In re Application of: Dan ROTTENBERG et al
Serial No.: 10/597,666
Filed: June 20, 2007
Office Action Mailing Date: March 28, 2008

REMARKS

For: DEVICE AND METHOD FOR
CONTROLLING IN-VIVO
PRESSURE

LETTER TO CHIEF DRAFTSMAN

FIG. 1A

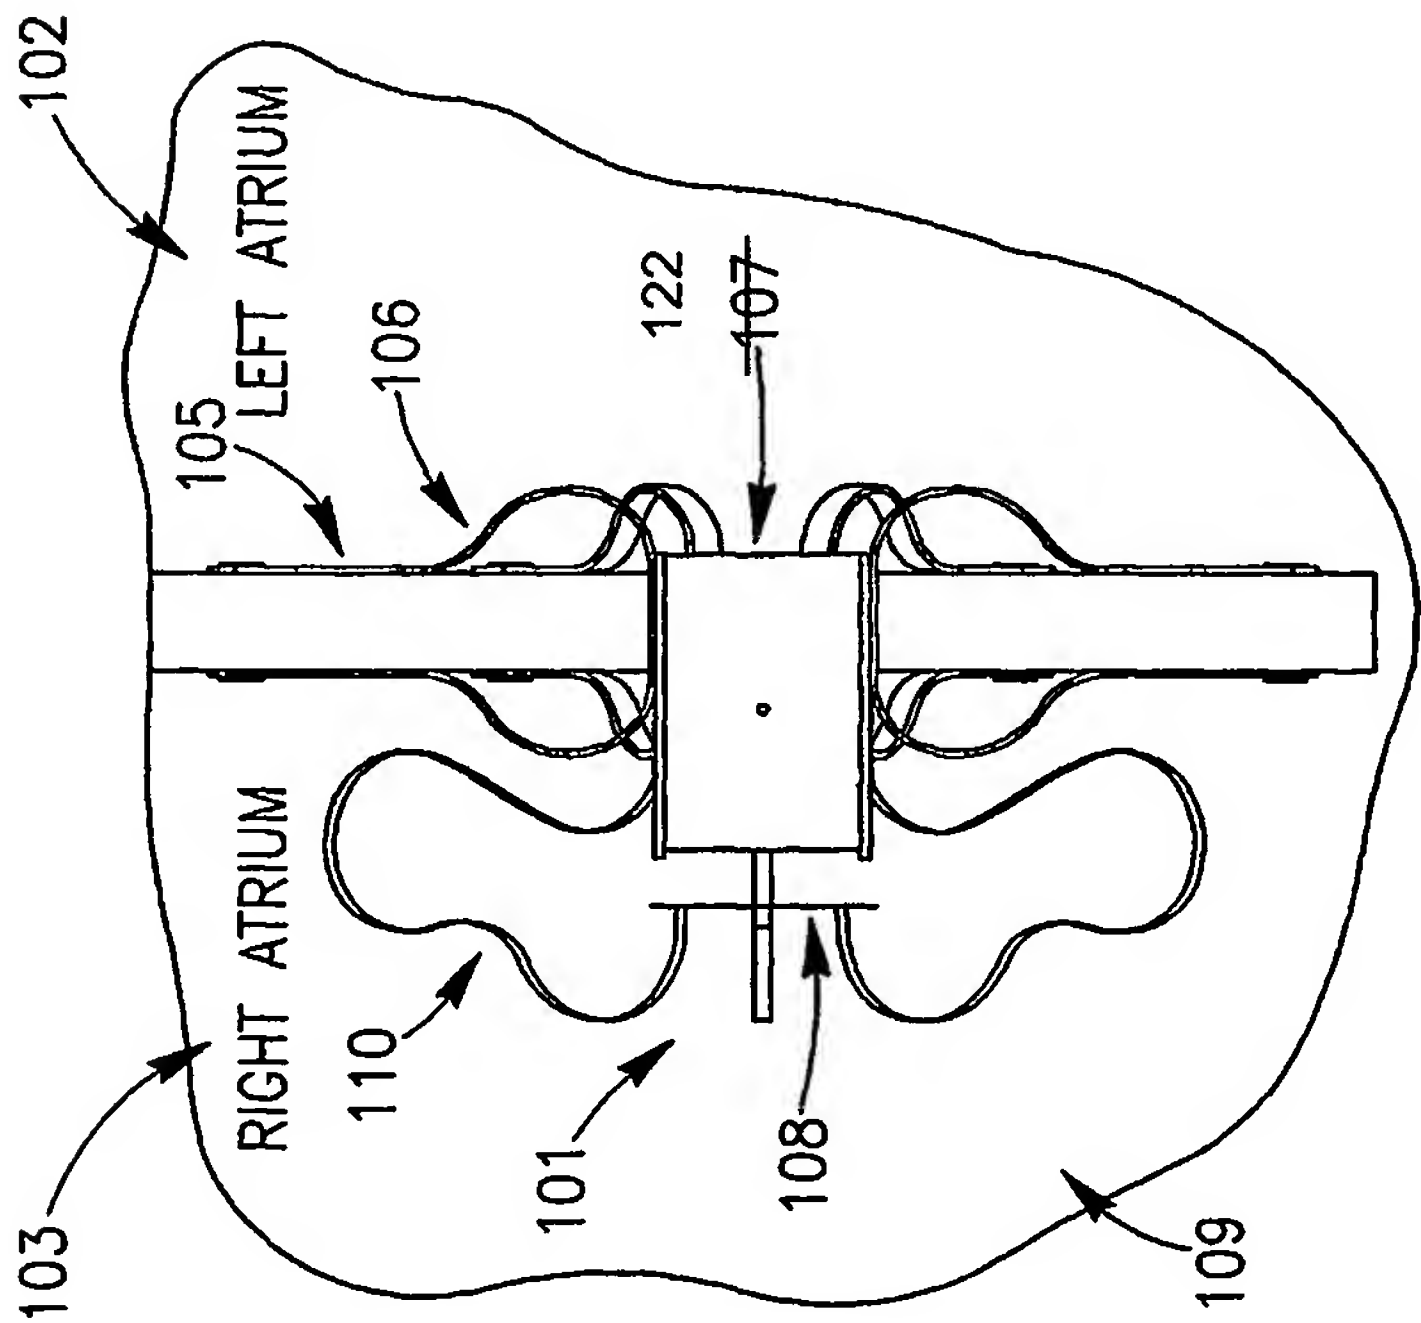
The Examiner objected that some terms used in paragraph [0036] of the specification, and as reflected in FIGS. 1B – 1I, were “unclear, inexact or verbose” within the meaning of 35 U.S.C. 112. In particular, the Examiner suggested “that the numbering of the same features should be given the same number, such as “shunt 122” should be changed to - - shunt 107 - - or - - shunt 107B ...”. The Applicant has carefully considered the Examiner’s suggestion and made the following amendments:

Permission is requested to correct Figure 1A as shown in red ink on the attached photocopy.

- in the drawings, FIG. 1A has been amended by changing number “107” to “122”; and
- in the specification, references to “shunt 107” in paragraphs [0036], [0037], and [0044] have been changed to “shunt 122”.

As a result of the above amendments the shunt shown in FIGS. 1A-1I and described in corresponding portions of the description is now uniformly referred to as “shunt 122”.
